MEMO

Project Variation of Hours of Use (Condition No.13 of permission 2019/93483)
Shakebees Adjacent 17 Hillhouse Lane, Fartown, Huddersfield, HD1 6EF

Reference 2025/92743

(Picture 3)

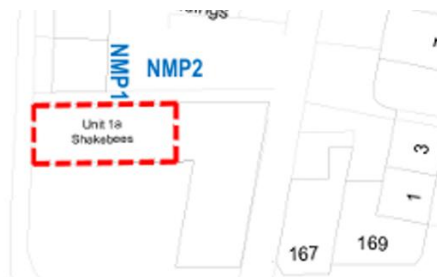
The measured noise level of the "Unsilenced Air Intake" was identified as 56 dB LAeq. However, as can be seen in the above ventilation extraction system (Picture 2), the air intake and the ventilation extraction system are not the same equipment. It is not clear where the "Unsilenced Air Intake" is positioned in relation to the noise monitoring positions or the nearest residential receptor. However, as can be seen in picture 2 (above), it is the ventilation extraction system that is within close proximity to the noise sensitive receptor that poses a potential noise impact.

It is correct that the air intake and the ventilation extraction system are not the same equipment.

For reference, the 'unsilenced air intake' is located as shown below (and also shown on Kirklees Council Environmental Health Picture 3 on the previous page):

The measured noise levels are most definitely from the 'unsilenced air intake' as confirmed by measurement immediately next to the intake (and not from the kitchen extraction system).

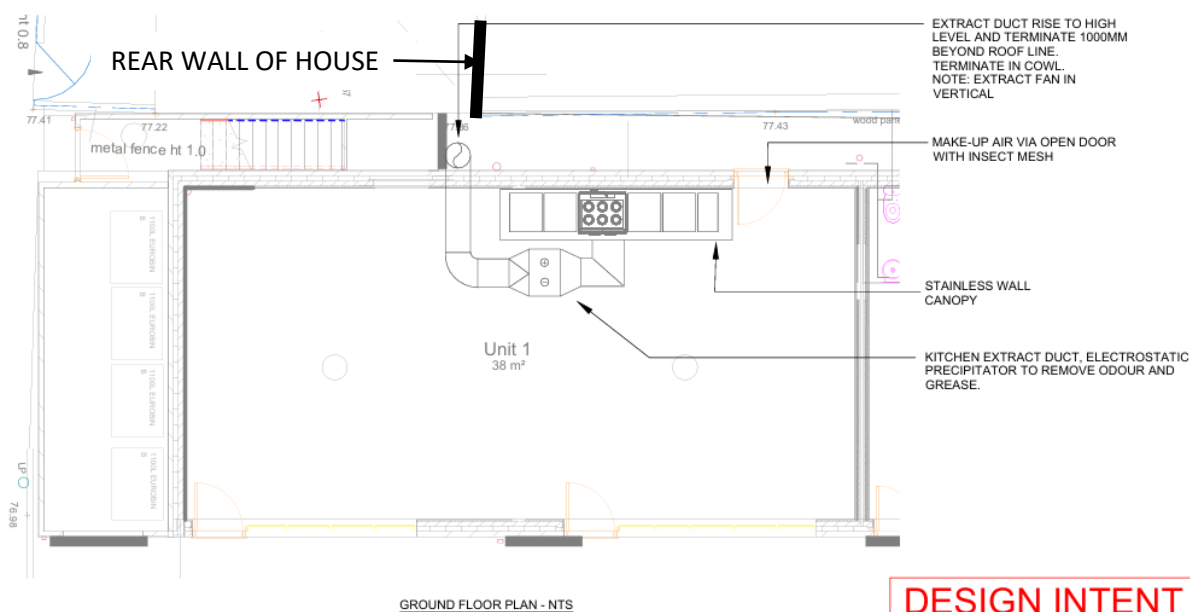
Furthermore, following the discharge of planning condition 15 for the kitchen extract ventilation system, an officer from the pollution team has witnessed noise from the kitchen ventilation extraction system which was considered to be “intrusive” during a site visit. It is not clear if the installed system is of kitchen canopy, pre-filters, electrostatic precipitator, bifurcated extract fan, outside noise attenuators and a high velocity roof cowl which is to terminate 1m above the apex of the roof is identical to those detailed in the drawing titled Mechanical Services Kitchen Ventilation Layout (drawing no. M001) (dated: Jan 23) by Shearstone Mechanical Building Services Consultancy and whether the kitchen ventilation extract system is cleaned and maintained in accordance with the manufacturers instructions such that noise levels from the system are higher than anticipated?

- a) The kitchen extraction fan is located slightly around the corner of the dwelling house and is not visible from habitable rooms windows (screening = noise attenuation), see below:

- b) The kitchen extraction system has silencers on the intake and outlet side of the fan (silencers = noise attenuation)

It is understood that the 2 no. windows nearest to the kitchen extraction system are not to habitable rooms.
